UNITED STATES PATENT AND TRADEMARK OFFICE

APPLICATION NO.	FILING DATE	FIRST NAMED INVENTOR	ATTORNEY DOCKET NO.	CONFIRMATION NO.
10/575,258	04/10/2006	Carlo Migli	Q93671	8810
23373 7590 08/14/2009 SUGHRUE MION, PLLC 2100 PENNSYLVANIA AVENUE, N.W. SUITE 800 WASHINGTON, DC 20037				
EXAMINER				
O'BRIEN, JEFFREY D				
ART UNIT		PAPER NUMBER		
3677				
MAIL DATE		DELIVERY MODE		
08/14/2009		PAPER

Office Action Summary

DETAILED ACTION

Annotated Fig. 2

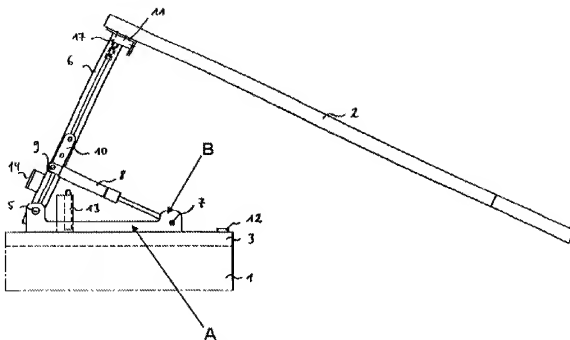
8. Claims 1-5, 7-8, 25, 33-34, and 37-40 are rejected under 35 U.S.C. 102(e) as being anticipated by Salice (US 7,497,532) herein referred to as '532.
9. For Claim 1, '532 discloses a hinge assembly (Fig. 2) for the connection of a vertically opening panel (2) to an element (1) between a closing position (Fig. 1) and an opening position (Fig. 2) comprising:

a supporting base (annotated Fig. 2: A);

a lifting lever (6) operatively connected to the panel (2) and directly hinged to the supporting base (A) about a first pivoting axis (at 5) between said closing and opening positions of the panel;

a balancing device (8) hinged to the supporting base (A) about a second pivoting axis (7) and acting on the lifting lever (6) along a direction of thrust defined by a line joining the second pivoting axis and a point of application of the thrust on the lifting lever to at least partially counterbalance the weight of the panel during rotation of the lever about said first pivoting axis (as seen in Fig. 2);

wherein the second pivoting axis (7) defines with the first pivoting axis (5) a dead center plane (as seen in Figs. 1-2);

wherein the first pivoting axis (5) and said balancing device (8) are positioned above an upper surface (3) of the element (1) in the mounting position of the hinge assembly (as seen in Figs. 1-2);

wherein in said closing position (Fig. 2) of the panel the second pivoting axis (7) is interposed between the panel (2) and the first pivoting axis (5); and

wherein the direction of thrust of the balancing device during operation is never below said dead center plane (as seen in Fig. 2).

27. For Claim 11, '711 teaches the hinge assembly according to claim 10, wherein said hollow body (20) is hinged to at least one supporting wall (22) extending laterally to the supporting base (18). Further, '532 discloses the hinge assembly hinged to a supporting wall (annotated Fig. 2: B) extending from the supporting base (A).
